Proposed Guidance Change to MC 0305 to Address Protracted Performance Indicator Results

Change to MC 305 Guidance:

Figure 1
Example Case 1 – Two White Performance Indicators

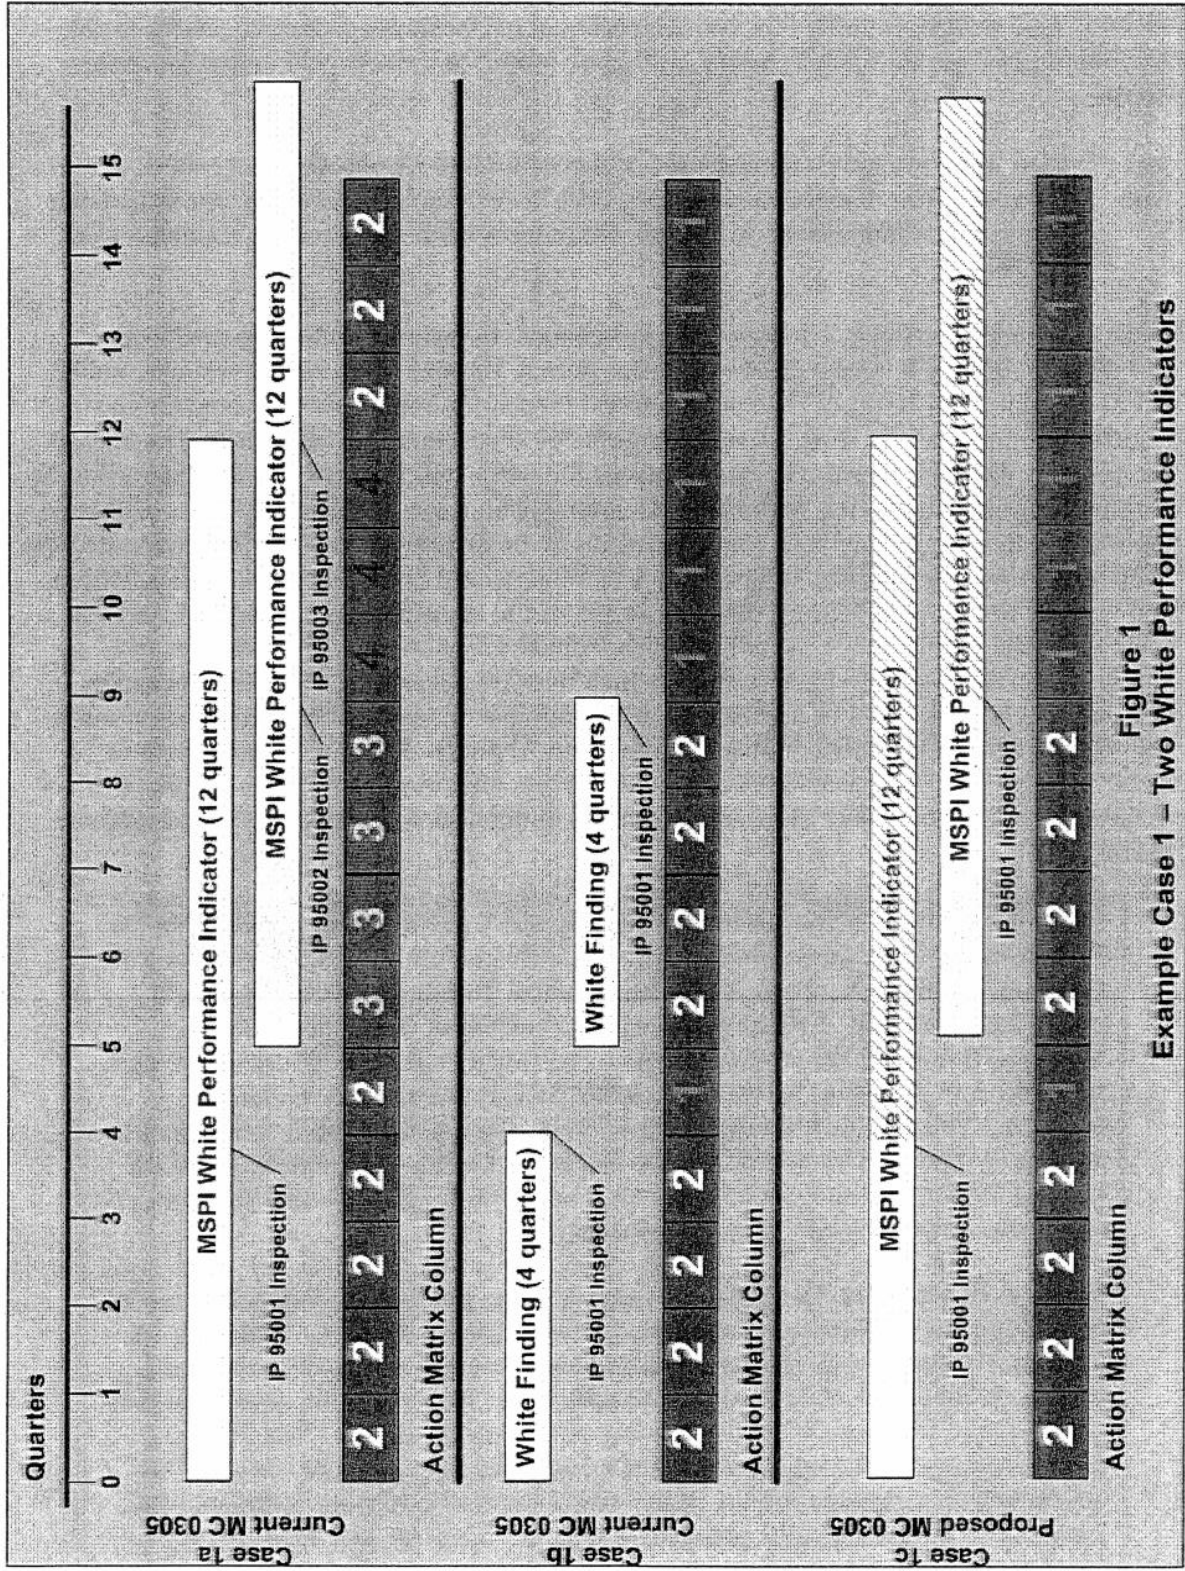
Example Case 1: Two White MSPI Performance Indicators

- Case 1a shows a White MSPI performance indicator occurring in quarter 1 and remaining for 12 quarters. Supplemental inspection activities (IP 95001) are completed by the end of quarter 4. A second White MSPI performance indicator in a different system occurs in quarter 6 and remains for 12 quarters. The first MSPI indicator is still White and in combination with the second MSPI indicator leads to a Degraded Cornerstone (Column 3) in the action matrix starting in quarter 6 and potentially² to a Multiple/Repetitive Degraded Cornerstone (Column 4) by quarter 10.

- Case 1b shows companion results for the case where the originating failures addressed by the performance indicator are instead addressed through inspection and the Significance Determination Process.

- Case 1c shows the effect of the proposed change where the MSPI results are removed from the assessment process upon completion of 4 quarters and completion of supplemental inspection activities.

Figure 2
Example Case 2 – White Performance Indicator & White Finding

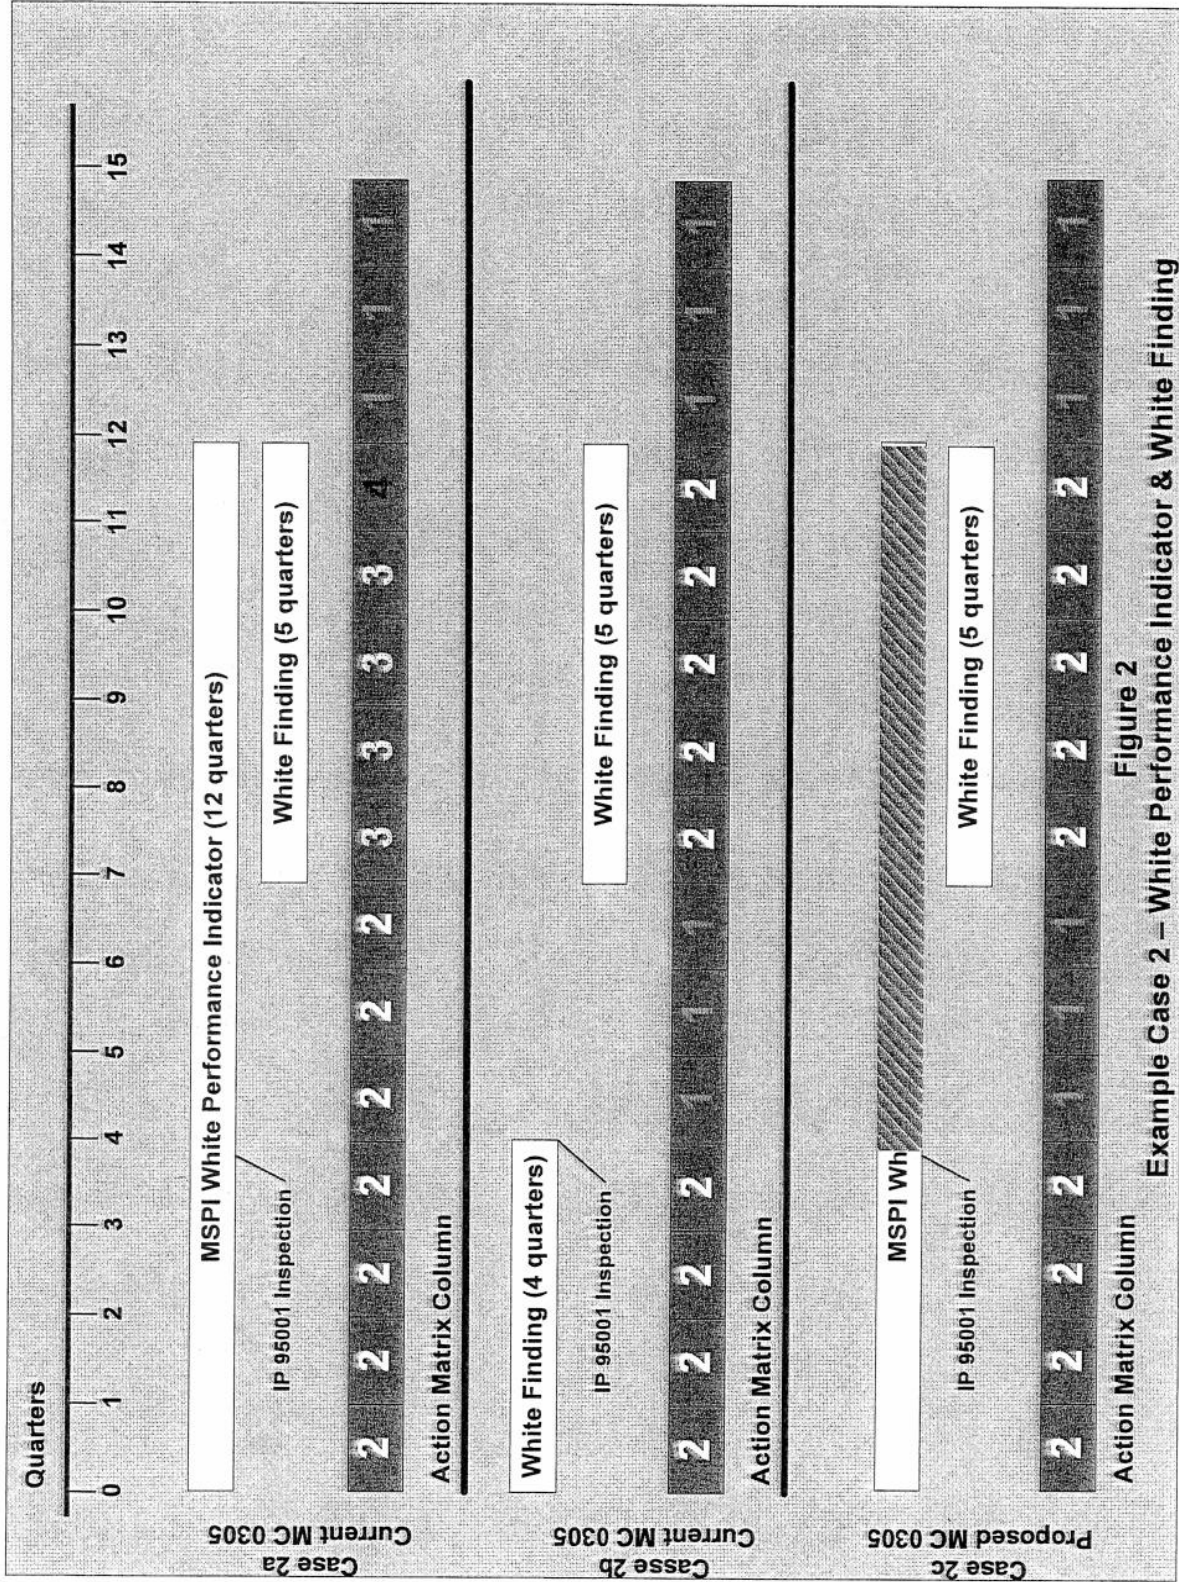
Example Case 2: Two White MSPI Performance Indicators

- Case 2a shows a White MSPI performance indicator occurring in quarter 1 and remaining for 12 quarters. Supplemental inspection activities (IP 95001) are completed by the end of quarter 4. A White finding in a different system within the Mitigating Systems cornerstone occurs in quarter 8 and remains for 5 quarters. The first MSPI indicator is still White and in combination with the White finding leads to a Degraded Cornerstone (Column 3) in the action matrix starting in quarter 8 and potentially to a Multiple/Repetitive Degraded Cornerstone (Column 4) by quarter 12.

- Case 2b shows companion results for the case where the originating failures addressed by the performance indicator are instead addressed through inspection and the Significance Determination Process.

- Case 2c shows the effect of the proposed change where the MSPI result is removed from the assessment process upon completion of 4 quarters and completion of supplemental inspection activities.
